PRODUCT CHANGE NOTIFICATION

#PCN-DC-YPCJ-13

Business Unit	Product Line Code	Type of Change	Action	Date of issue
DC	AAC	Aesthetic	Notify Distributors and Field	5/24/2013

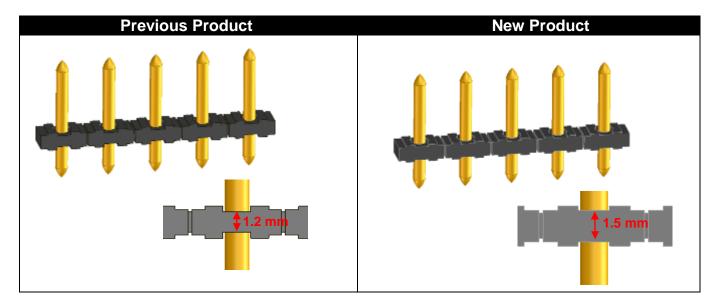
Due to our continuous improvement process the above mentioned parts will be delivered with a modified housing outline as shown on the pictures. The plastic part will become 0.3 mm higher around the soldering pins. All other dimensions and technical data remain the same. During the conversion period both versions will be delivered depending on the inventory.
